TRANS/WP.29/GRSP/2003/11
24 March 2003

**PROPOSAL FOR DRAFT AMENDMENTS TO REGULATION No. 44
(Child restraints)**

Transmitted by the Expert from Germany

Figure 1, amend to read :

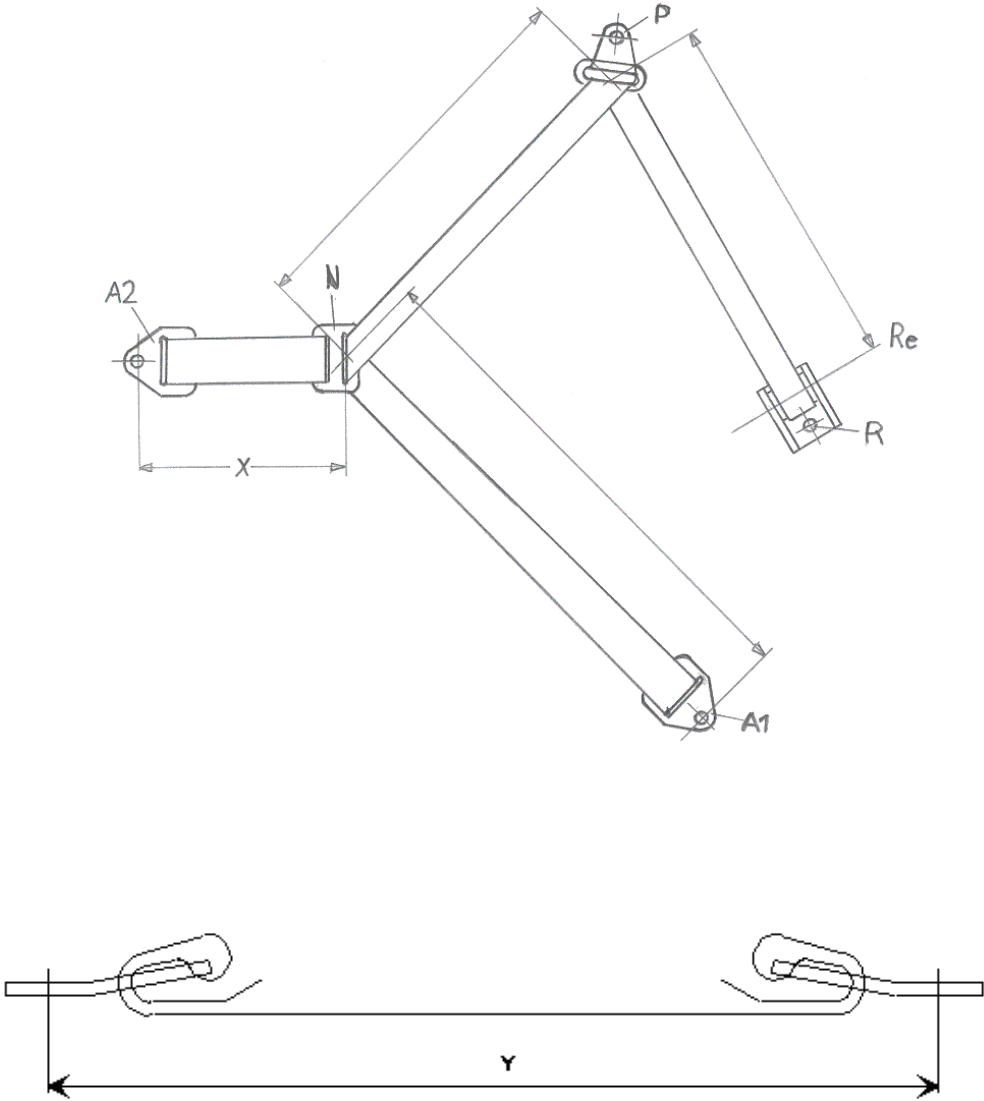
" two anchorages points (A1 and A2) (see Figure 1), and a central part (N, in detail in Figure 3). The retractor

Belt retractor R shall be fitted to trolley anchorage such that the spool centre-line is positioned on Re

The value of X in Figure 1 below is 200 ± 5 mm. The strap length between A1 and the centre-line of the retractor spool Re for testing of universal and semi-universal categories shall be 2820 ± 5 mm when measured in a straight line without load and on a horizontal surface; this length may be increased for testing of restricted category; for all categories

with the child restraint installed there shall be a minimum of 150 mm of strap length on the retractor spool."

The 03 series of amendments neglected to prescribe a distance between the retractor spool centre line and the retractor anchorage hole. This resulted in different strap lengths. By referring to the spool centre line the strap lengths are always the same ones without prescribing the retractor.
